# THE CITY OF NEW YORK MANHATTAN COMMUNITY BOARD 3

RE: CB3 Comments on Draft Scope of Work for Two  
Bridges LSRD

The following details the comments of Community Board 3 (“CB3”) on the Draft Scope of Work (“Scope”) for the Draft Environmental Impact Statement (“DEIS”) that will study the environmental impacts for the proposed amendments to the Two Bridges Large-Scale Residential Development Plan (LSRD).

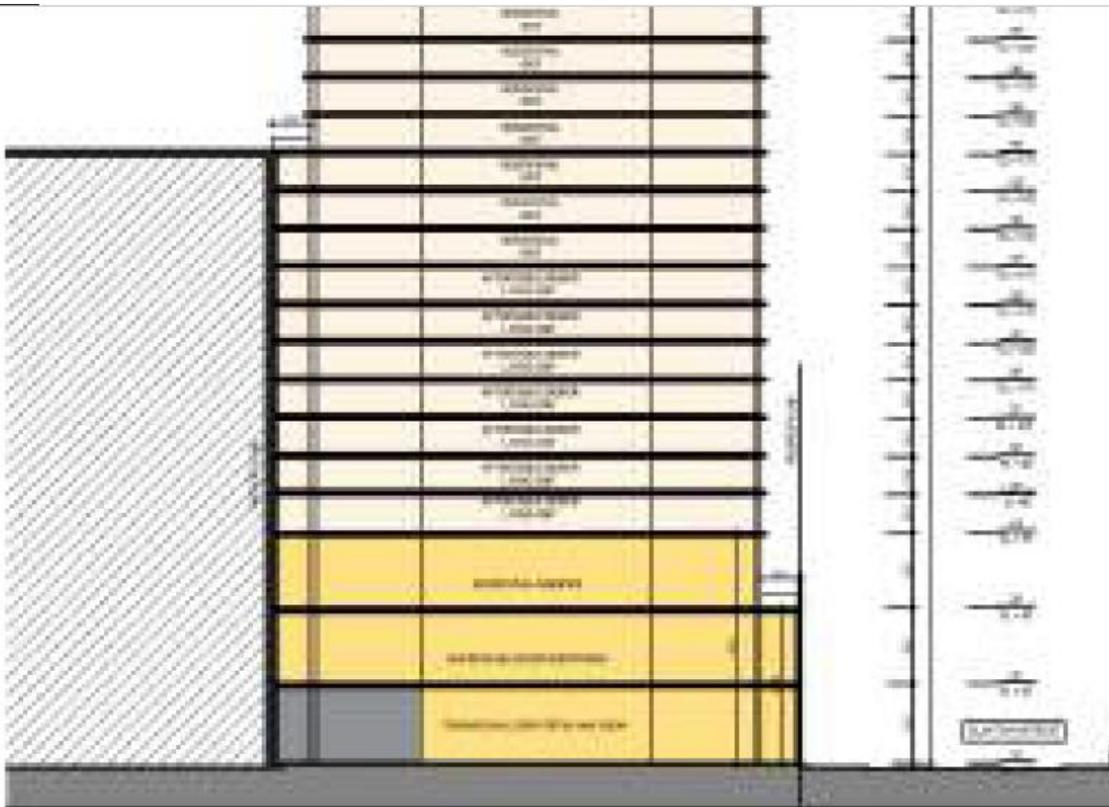
Further, because information about the project comes from different developers, they all follow different standards in their drawings, produced at different resolutions, which makes them difficult to compare. For example, the following is a detail of the Site 6 Illustrative Section (Figure 12), which shows that the text on the drawing cannot be read, as reproduced below:

Drawings that include numbers and text that cannot be read need to be corrected. All drawings need to be legible and should follow the same standards so they can be more easily compared. For example, site six seems to have a much more reasonable use of mechanical space when compared with site 4A/B. However, it is difficult to say with certainty because the drawing is not legible and the drawings use different standards. The Lead Agency should select a standard and then instruct the individual developers to submit drawings that follow that single standard so that the scope of the project is clearly disclosed to the public.
